UNITED STATES DEPARTMENT OF COMMERCE United States Patent and Trademark Office Address: COMMISSIONER FOR PATENTS P.O. Box 1450 Alexandria, Virginia 22313-1450 www.uspto.gov

| APPLICATION NO. | FILING DATE | FIRST NAMED INVENTOR | ATTORNEY DOCKET NO. | CONFIRMATION NO. |
|---------------------------|----------------------------------|----------------------|---------------------|------------------|
| 10/577,067 | 04/24/2006 | Ryuichiro Amano | DK-US065040 | 4109 |

| | Application No. | Applicant(s) | | | | |
|--|---|-----------------------|--|--|--|--|
| Office Action Summers | 10/577,067 | AMANO, RYUICHIRO | | | | |

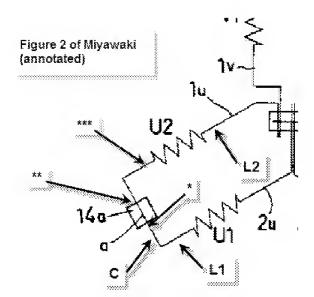
a first lead-out wire [L1] extending from another end of the first tooth winding portion [U1] (see annotated figure 2; below),

a crossover wire [C] having one end connected to the first lead-out wire [L1] and extending to a position which is radially outside (figure 3) of the second tooth winding portion [U2] at which the crossover wire [C] is on the second tooth winding portion (annotated figure 2; below),

a power wire [u] having a first portion with an end [*] connected to another end of the crossover wire [C], and a second portion with an end connected to another end [**] Application/Control Number: 10/577,067

of the first portion (the first and second portions are parts of a single wire, [u]) and another end [***] connected to an end of the second tooth winding portion [U2] (see annotated figure 2; right),
